# Aesthetic Assessment and Recommendations for the Proposed VELCO Lamoille County Project Transmission Line and Substation Upgrades

Docket No. 7032, VELCO Lamoille County Project

Submitted to:  
State of Vermont  
Department of Public Service  
Montpelier, VT

Submitted by:  
LandWorks  
Middlebury, VT

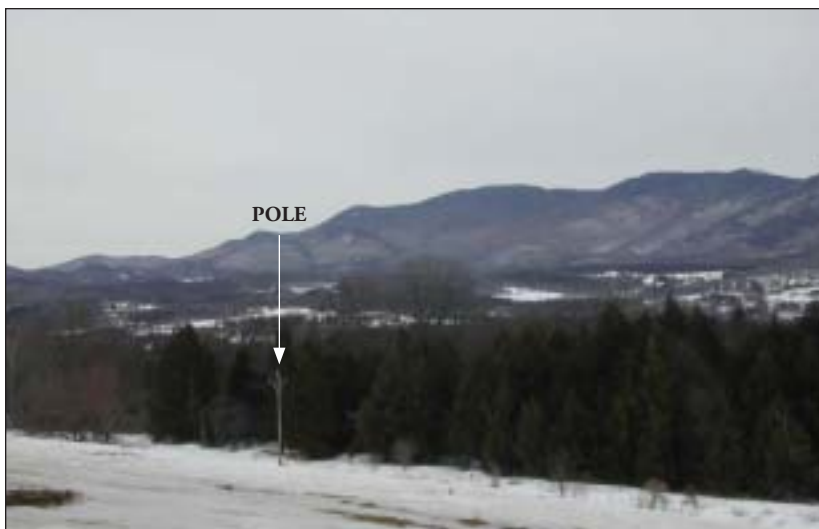
**Approx.  
Mile 2.7  
- 2.8** View east to existing corridor.  
Higher poles will result in  
skylining. This is a very sensitive  
area.

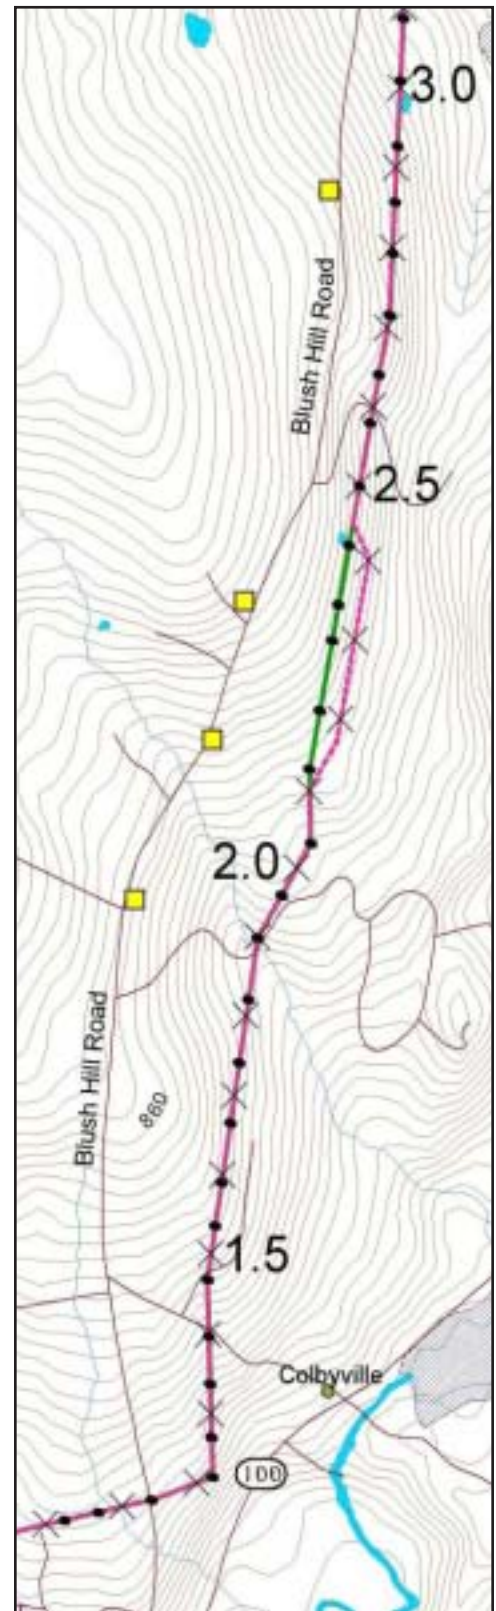
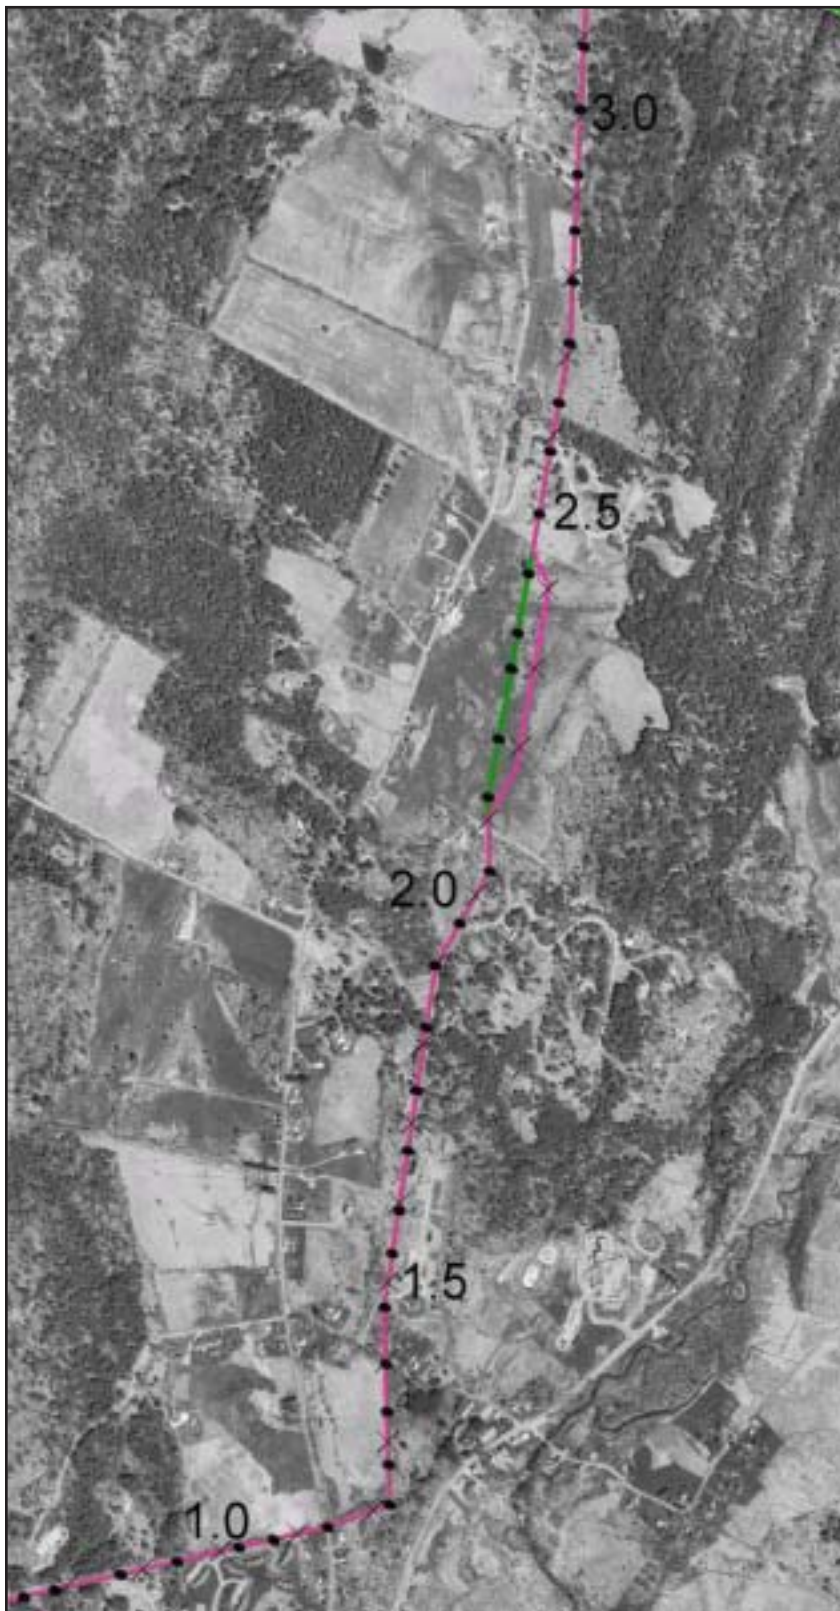
**Approx.  
Mile 2.8  
- 2.9** New poles should be below  
treeline so as not to exceed  
height of trees, which provide  
critical "backgrounding".

### Mile 3.6

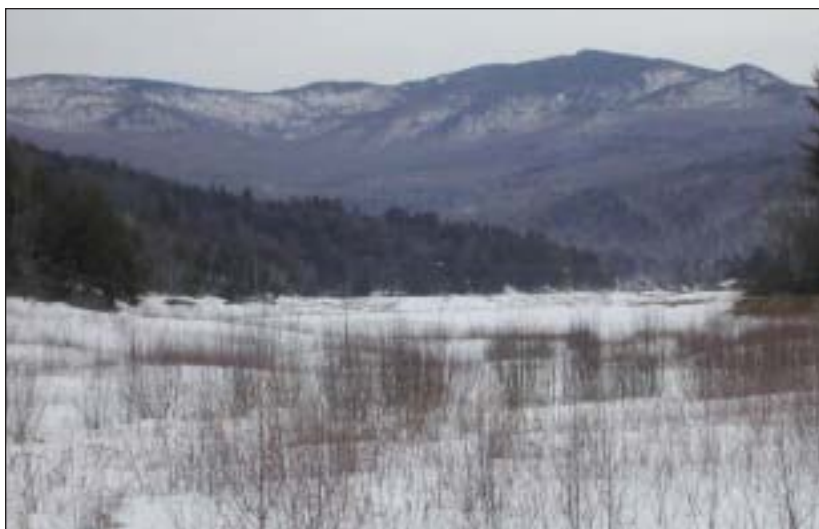
View of the transmission corridor from the Blush Hill access area across Waterbury Reservoir. The widening of the corridor and subsequent cut on the hill-side will substantially impact the appearance of the corridor and its "cut" from the boat launch. This section with the addition of a new line and corresponding structures up to Mile 4.0 will result in an undue adverse impact to the reservoir and its users.

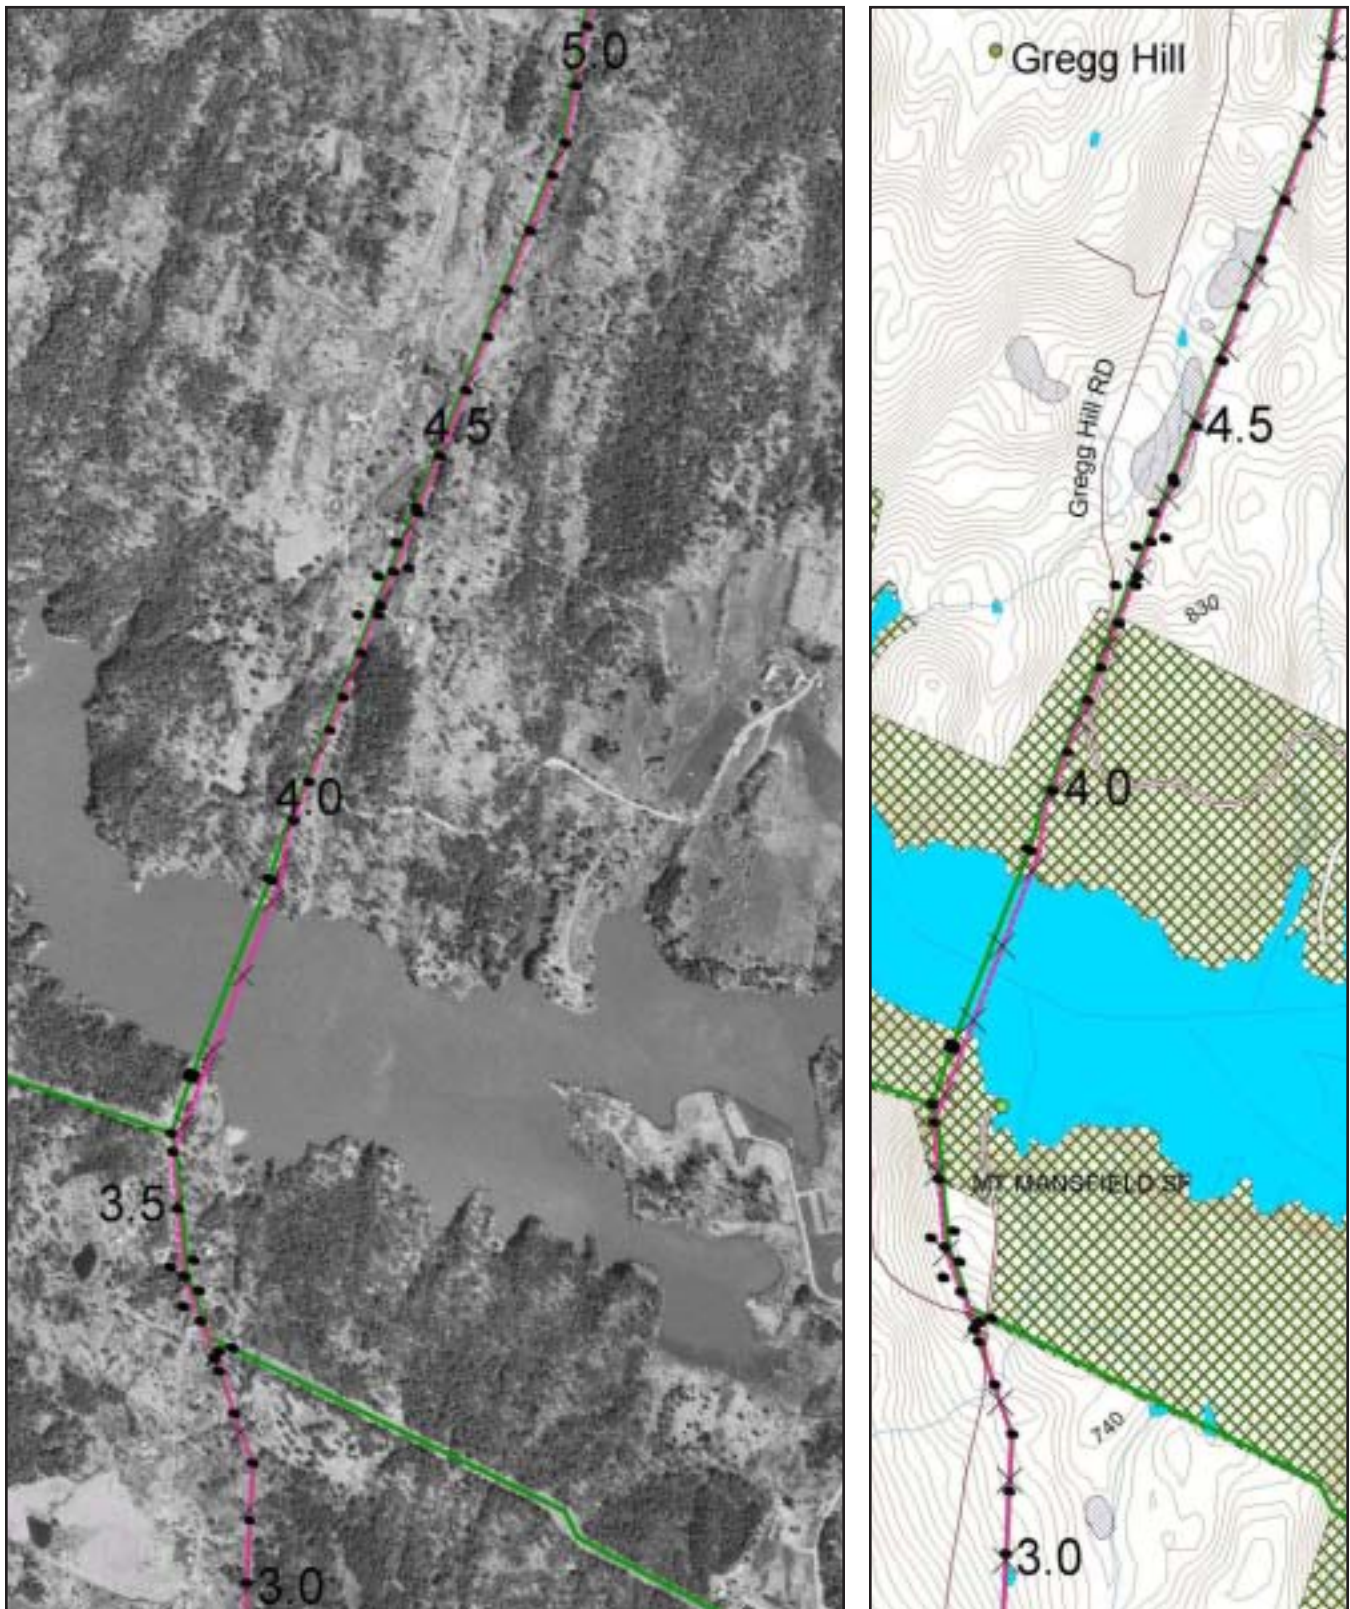
**Mile 4.1** Looking north at the crossing the lines are right in view. Background vegetation is critical and must be kept.

### Mile 6.0

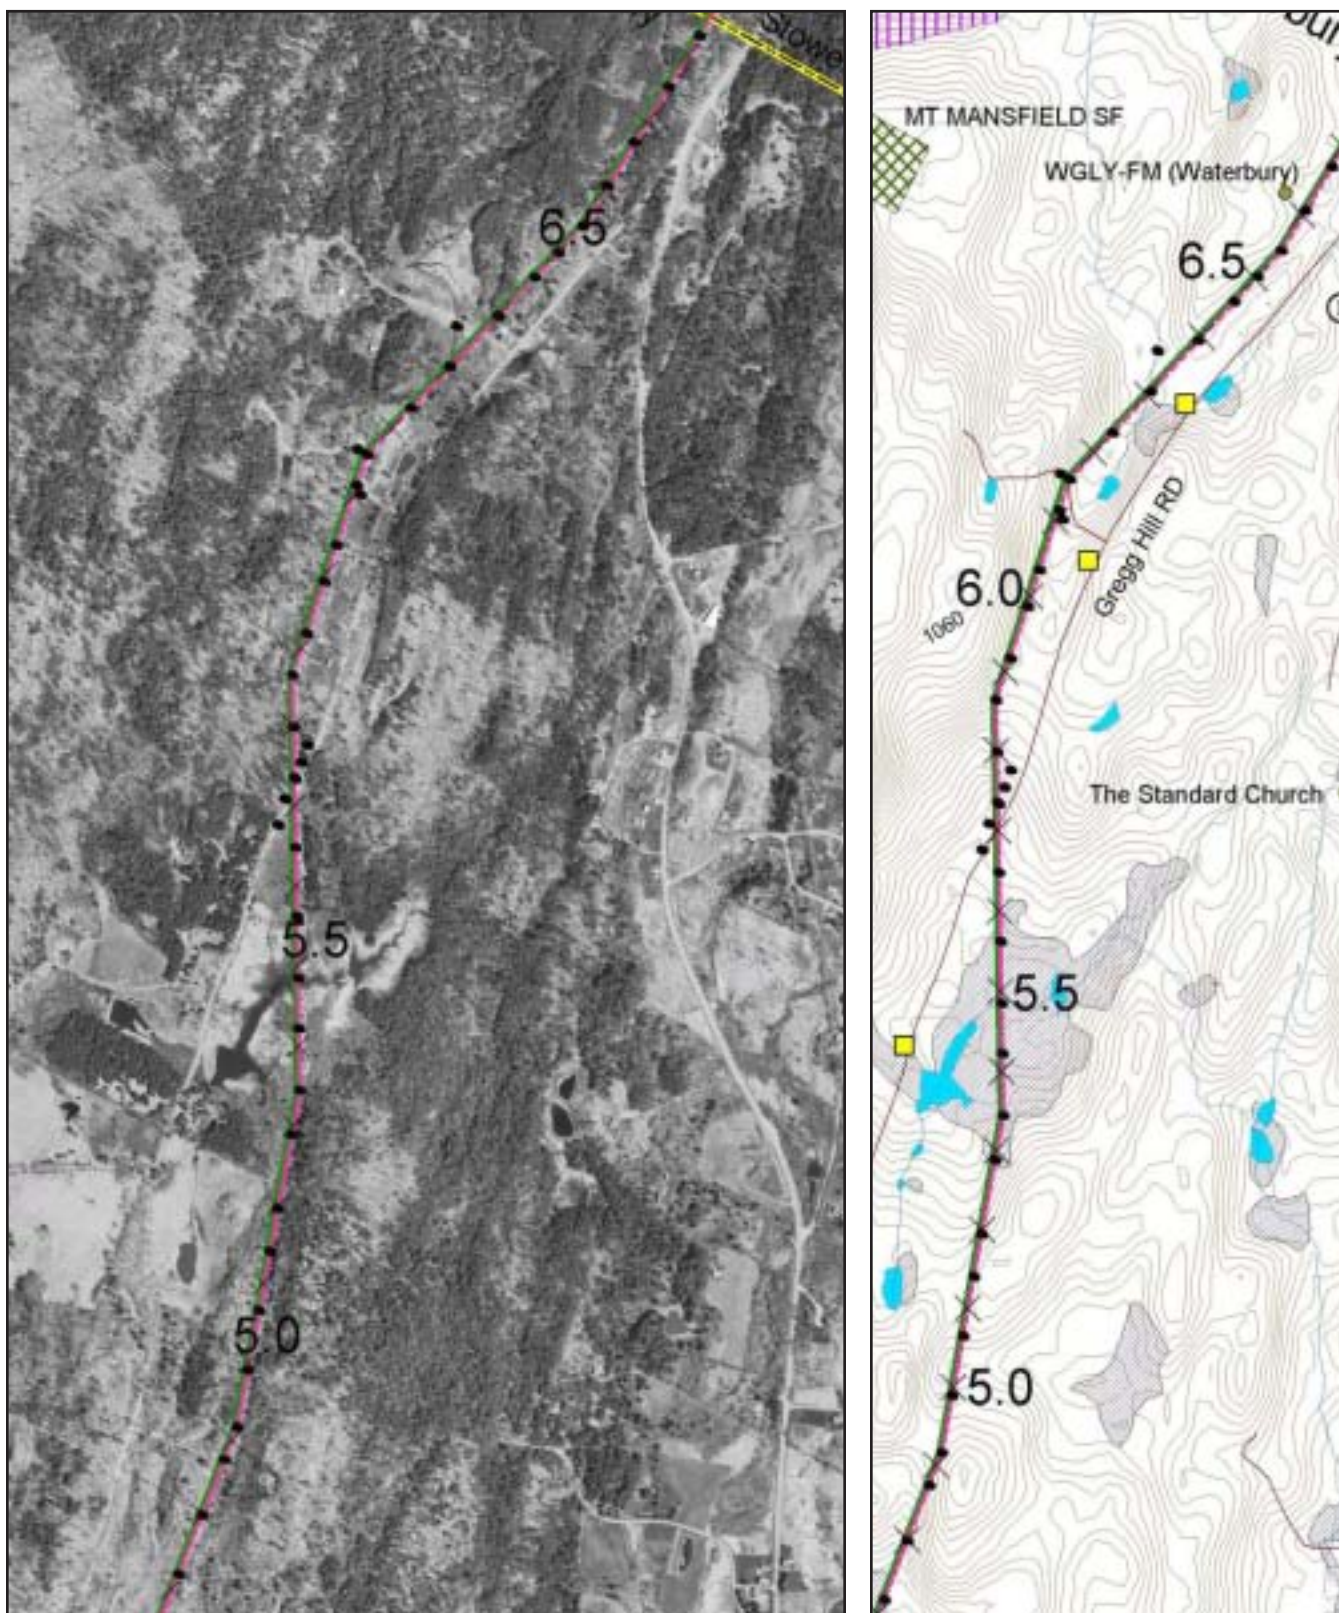
The existing corridor is east of the residences along Gregg Hill Rd. Vegetation in foreground must be retained, and in some instances, added to.

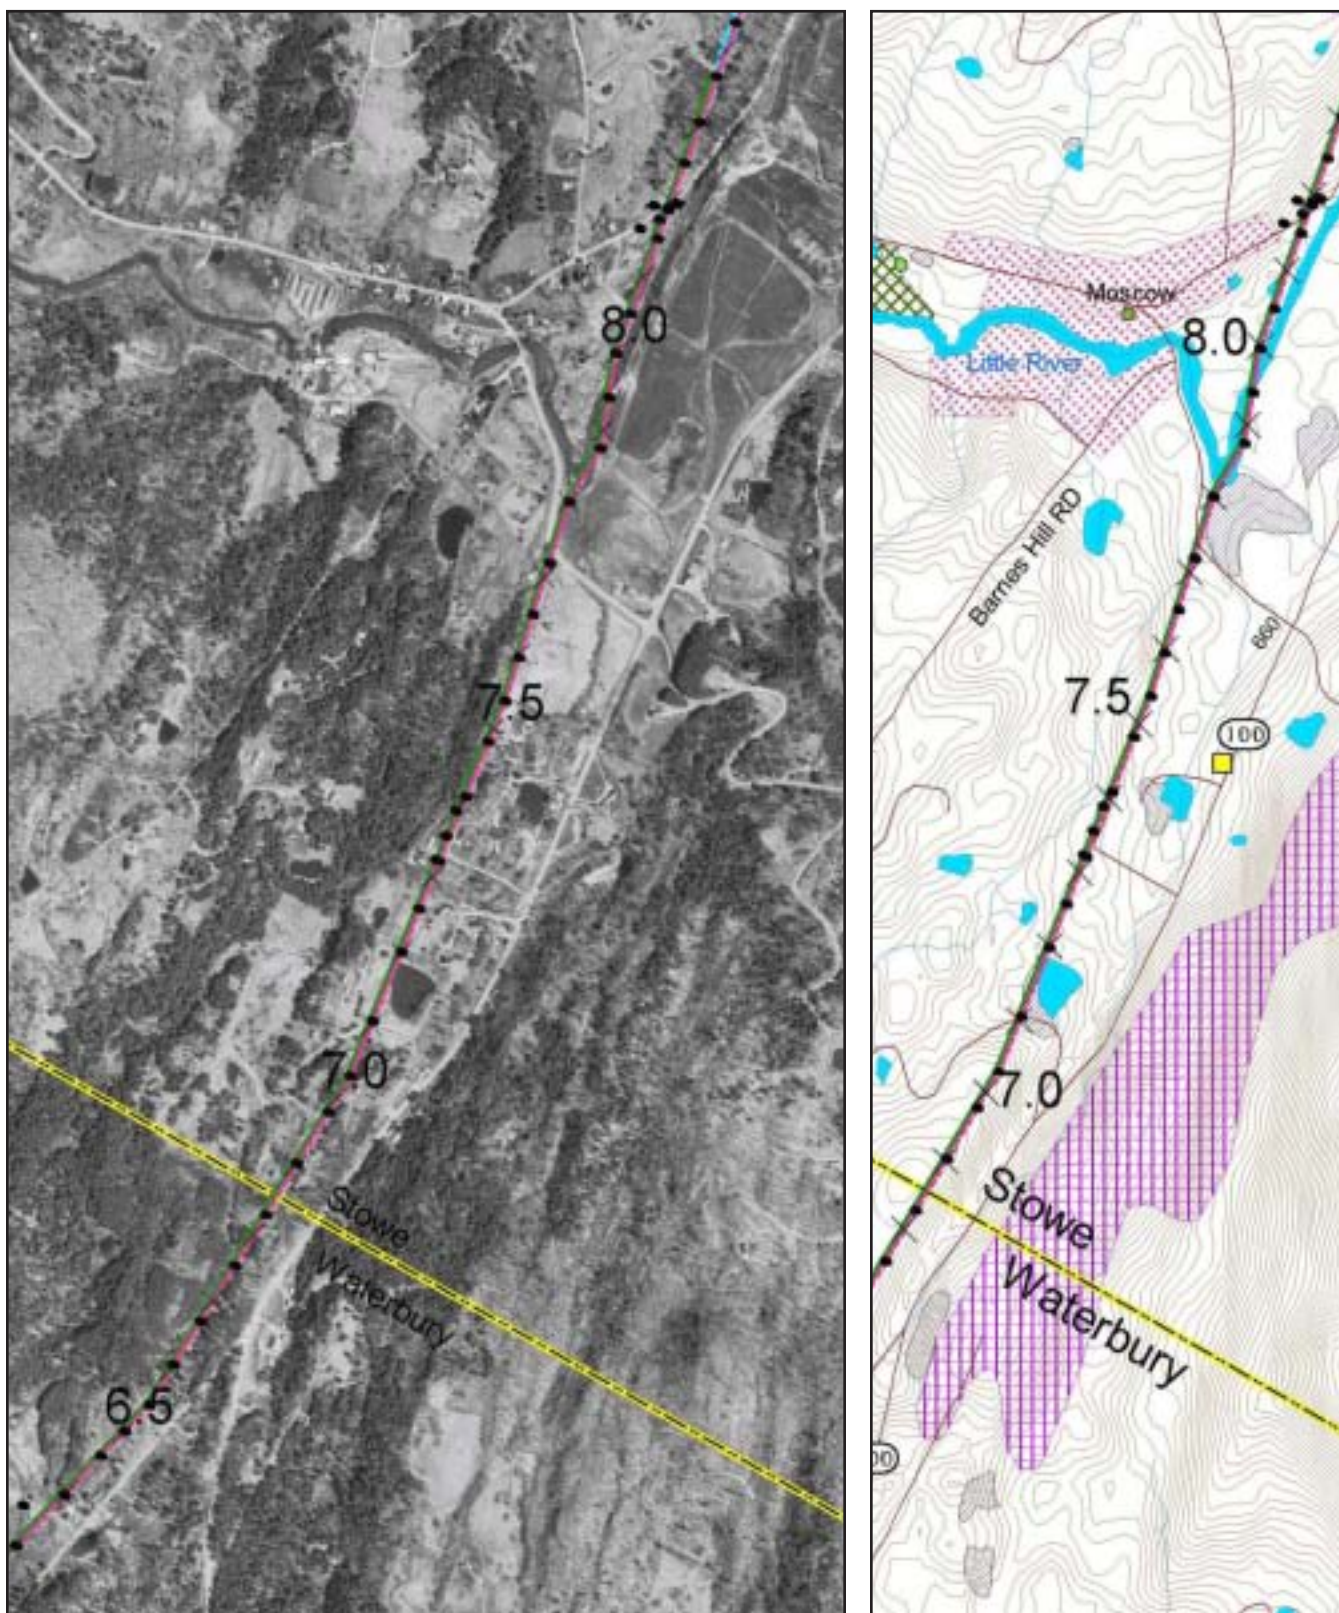
View up corridor at entry to Black Bear Run development. Corridor goes through community land and adjacent to pond. Some roadside / street trees planted here will limit an adverse impact.
